COLLIN COUNTY
FRONTIER PARKWAY PAVING AND DRAINAGE IMPROVEMENTS
Dallas North Tollway to S.H. 289 (Preston Road)
Project No. IFB 2020-303

CHANGE ORDER NO. 6

SHEET NO.
GC19A

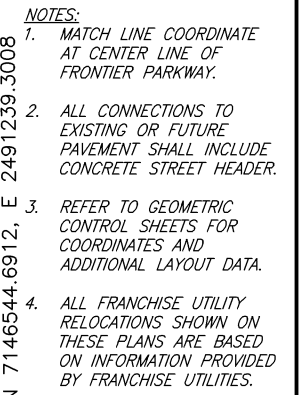
The City of Celina has requested an additional left turn storage bay for the proposed Sage Retail Addition. The new left turn storage bay is for eastbound Frontier turning north at Sta. 86+07.76 to Sat. 88+65.66. Affected construction plan sheets GC19A, P18A and PM18A, marked "Change Order No. 6" in the lower left-hand corner, are attached hereto and made a part of the construction contract.

6 CHANGE ORDER NO. 6 - ADD LEFT TURN LANE (150' STORAGE) (04/06/2023)

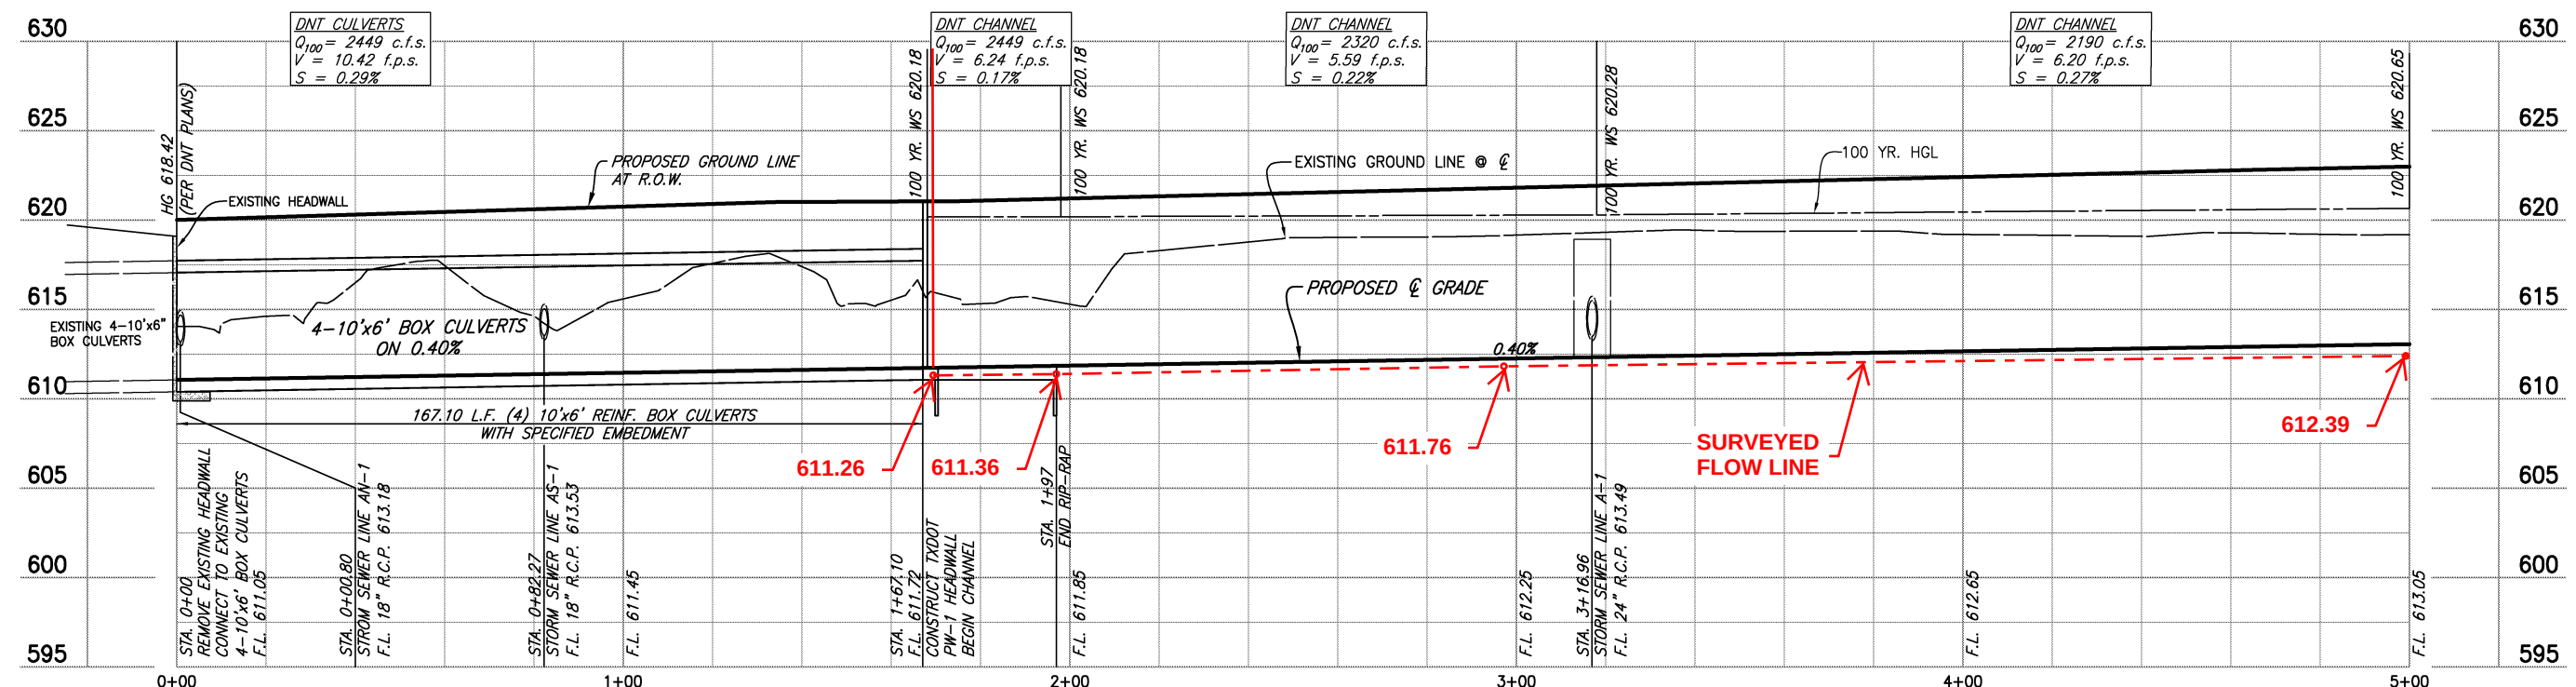
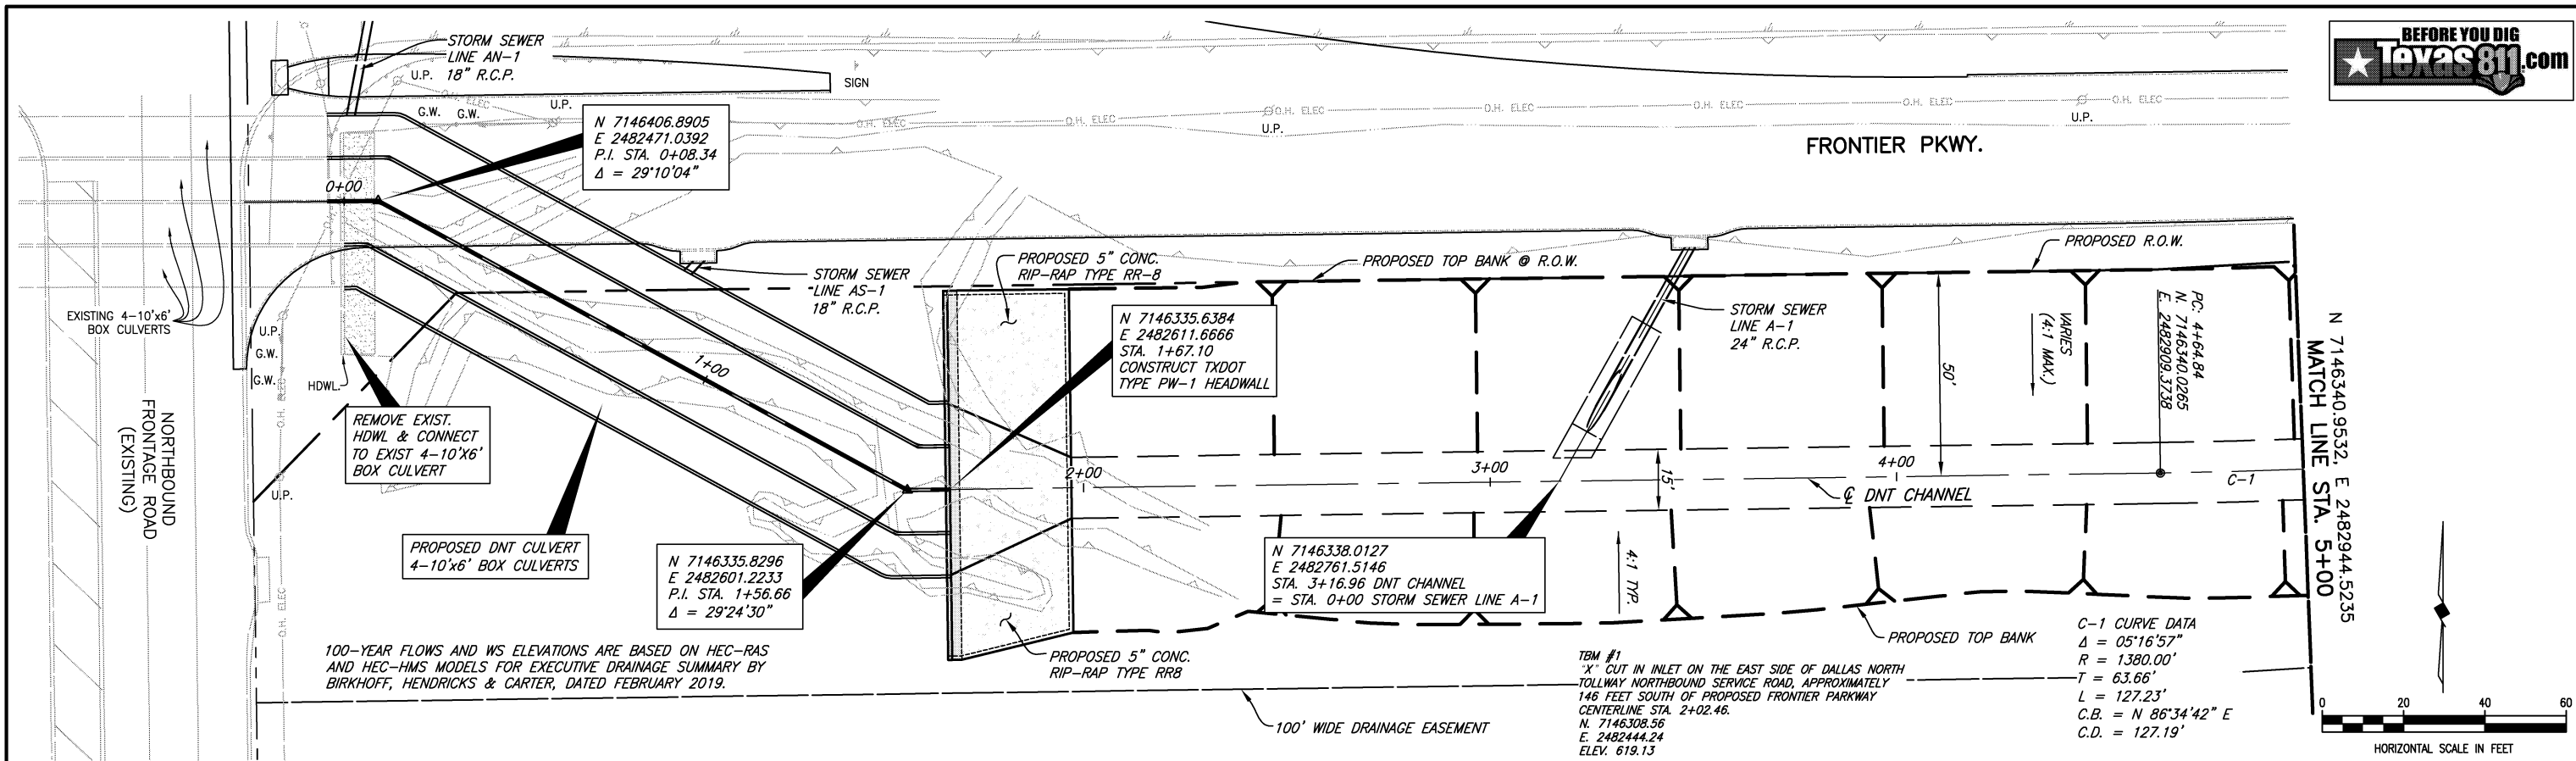
6 CHANGE ORDER NO. 6 - ADD LEFT TURN LANE (150' STORAGE) (04/29/2023)	These plans and related specifications were prepared for construction of this specific project only. Reuse of these documents is not permitted without written authorization of Birkhoff, Hendricks & Carter, L.L.P. If this drawing is converted to an electronic file, if any discrepancy occurs between the electronic file and the Birkhoff, Hendricks & Carter, L.L.P. original document, the original document will govern in all cases.	BIRKHOFF, HENDRICKS & CARTER, L.L.P. PROFESSIONAL ENGINEERS TBPE Firm No. 526; TBPLS Firm No. 10031800 11910 Greenville Ave., Suite 600 Dallas, Texas 75243 (214) 361-7900		 Sgt. 4, 2020	COLLIN COUNTY, TEXAS FRONTIER PARKWAY PAVING AND DRAINAGE IMPROVEMENTS PERMANENT SIGNING, MARKINGS, BARRIERS & CONDUITS STA. 85+00 TO STA. 90+00	BHC PROJECT NO. 2016-137 April 2023	SHEET NO. PM18A
--	--	---	---	---	---	--	-------------------------------

SHEET NO.
D15

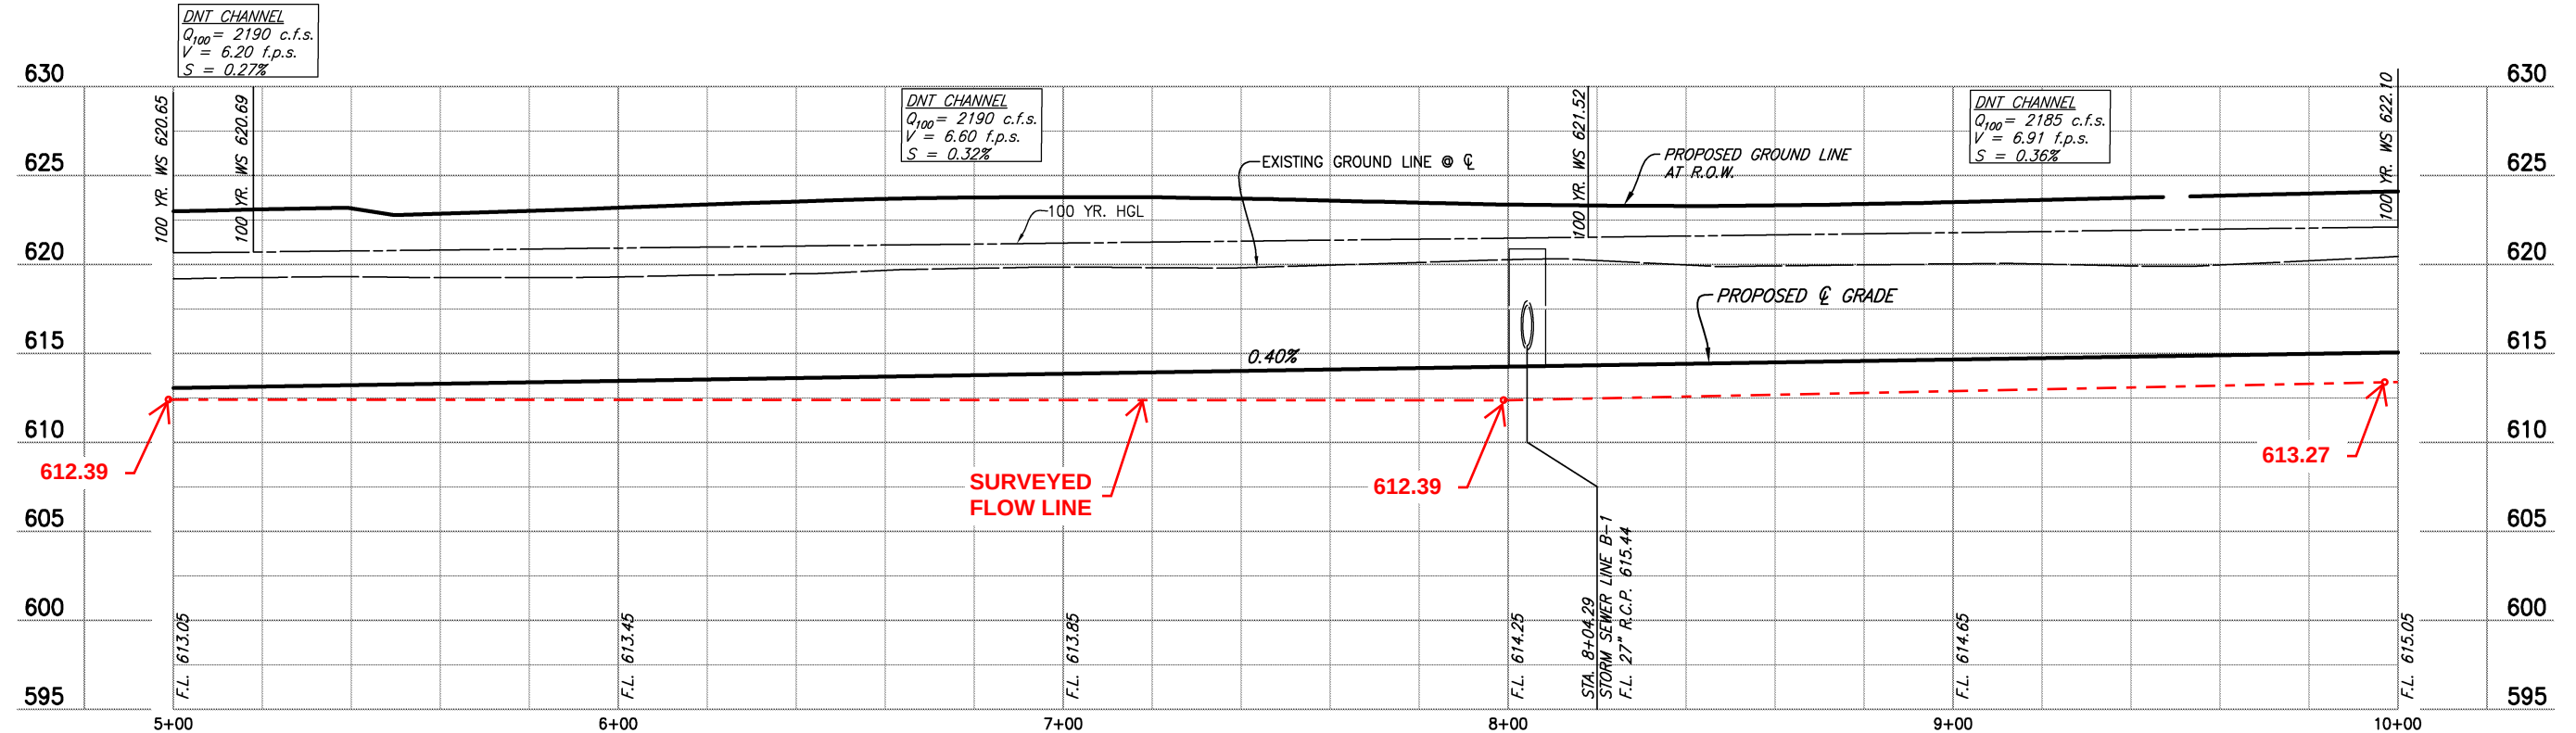
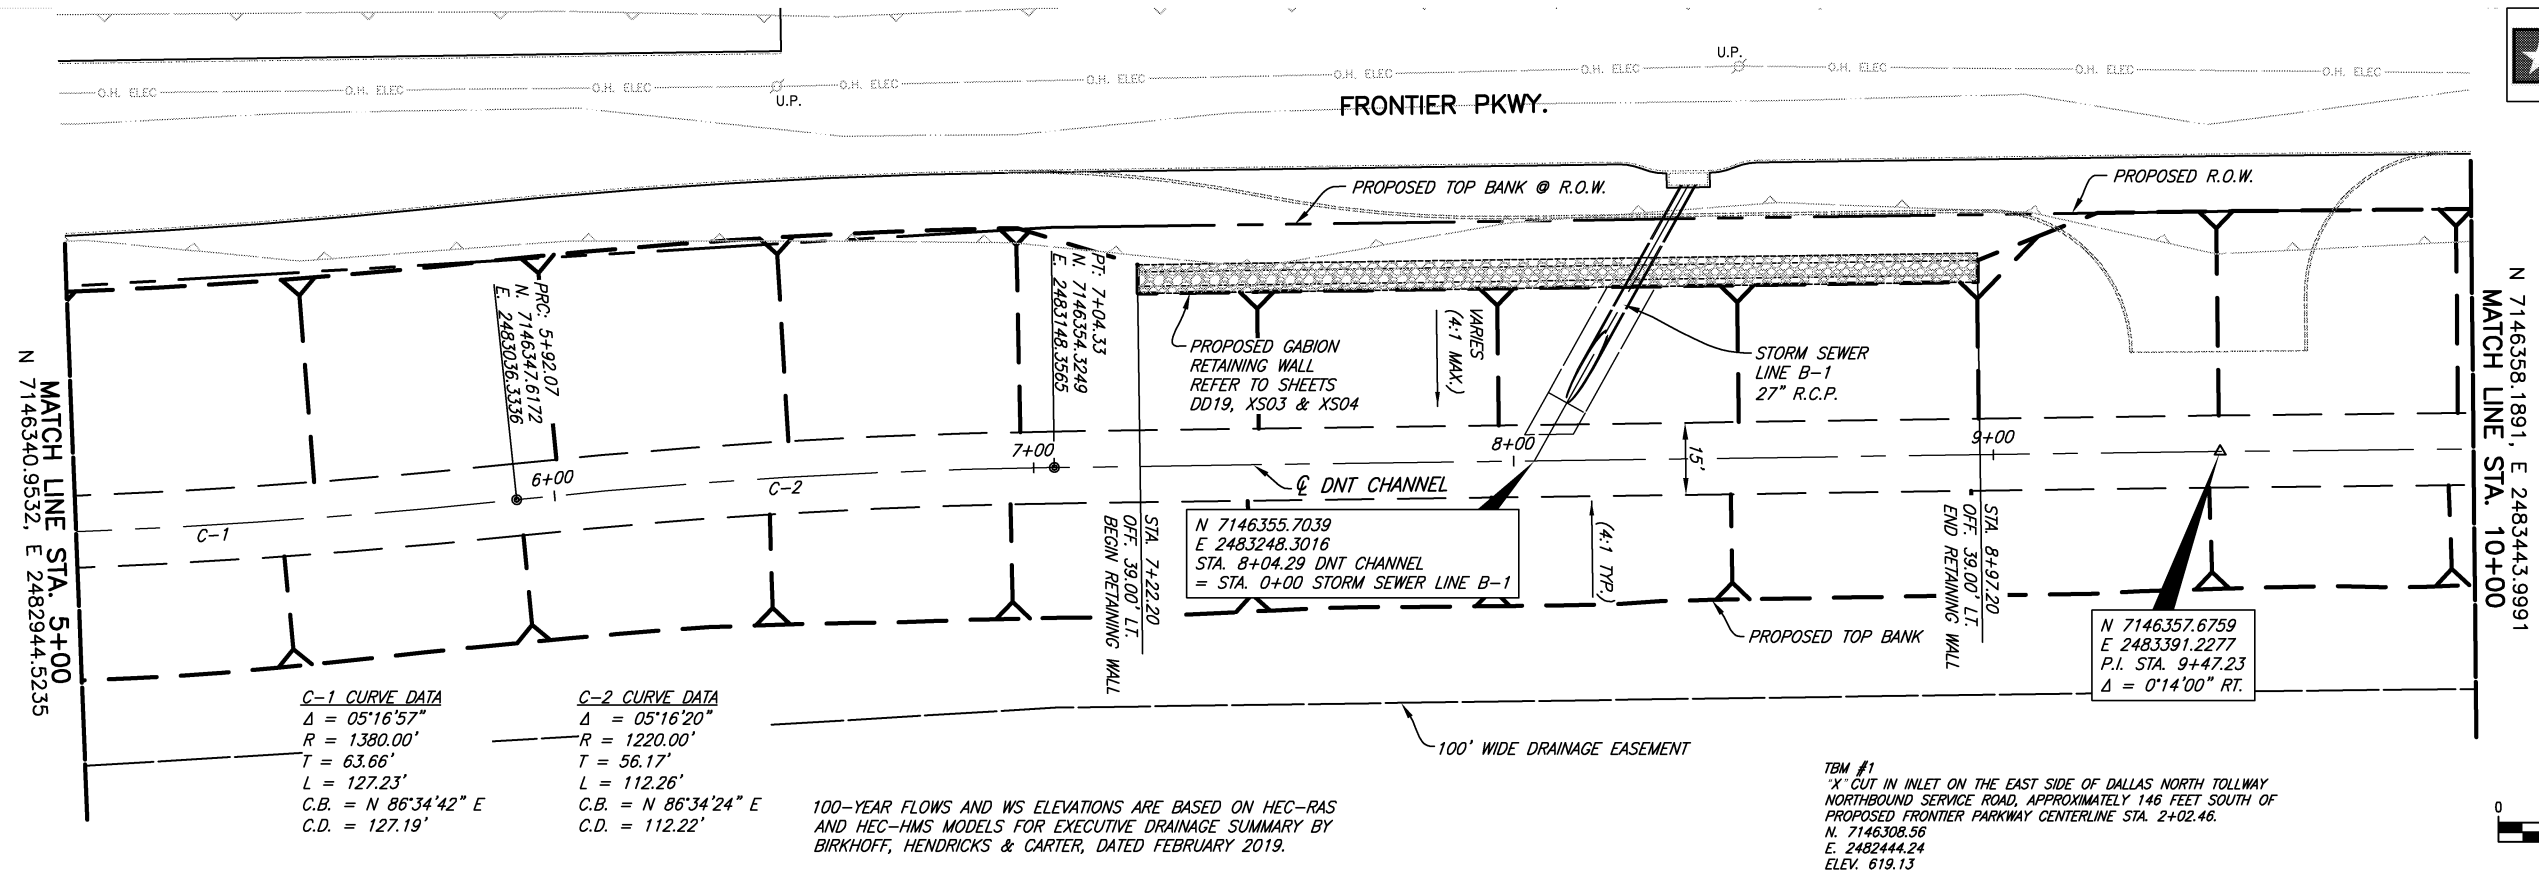
- a) Regrading the channel from the downstream edge of the existing gabion mattress to match the existing channel flowline 300 feet downstream.
- b) Constructing a 15-foot wide by 8-inch thick gabion mattress with 18-inch deep toe walls on all sides in the channel bottom from the downstream edge of the existing gabion mattress for a distance of 100 feet downstream.

- c) Constructing a geogrid material infilled with growth media and a Bermuda grass seed mixture on both side slopes for 28-feet (or a height of 7 feet above the channel bottom). The recommended material for the geogrid and growth media is Futerra 7020 TRM and ProGanics Dual, with Platipus Zip anchors in an 18-inch anchor trench as manufactured by Profile Products, L.L.C., contact Matt Skinner at email MSkinner@profileproducts.com and phone 832-773-4030.

- d) Constructing the geogrid material infilled with growth media and a Bermuda grass seed mixture from the downstream edge of the proposed gabion mattress channel bottom to a distance of 200-feet downstream. The geogrid material infilled with growth media and a Bermuda grass seed mixture shall be 28-feet each side of the channel bottom transitioning to 12-feet each side of the channel bottom 200 feet downstream and shall

extend across the channel bottom for the entire 200-foot length downstream of the proposed gabion channel bottom. All the geogrid areas shall be provided with an 18-inch anchor trench on all sides and recommended anchors.

- e) Construction Plan Sheets D15-D19 marked “Change Order No. 6” in the lower left-hand corner of the sheet are attached hereto and made a part of the construction contract.
- 3) Final Construction Quantity Reconciliation (Collin County, Celina, Prosper)
- a) Reconciliation of Under Run Work Item Quantities
 - b) Reconciliation of Over Run Work Item Quantities
